# HYUNDAI

## Technical Service Bulletin

GROUP	NUMBER
<b>BODY ELECTRICAL</b>	<b>23-BE-009H</b>
DATE	MODEL(S)
<b>JULY 2023</b>	<b>VENUE (QX)</b>

**SUBJECT:** HORN ASSEMBLY WARRANTY EXTENSION (TXXU) AND REPLACEMENT

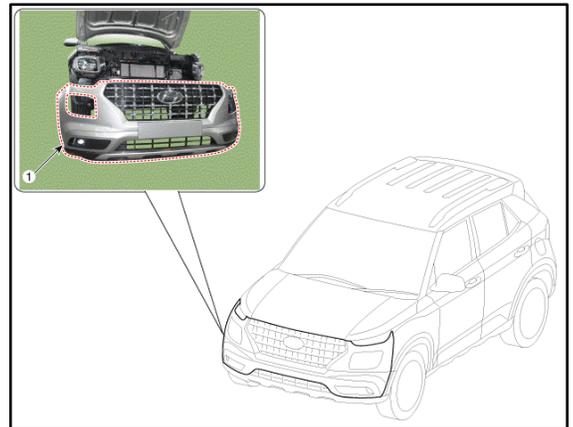
2. Remove the horn (A) after disconnecting the horn connector and loosening the mounting bolt.
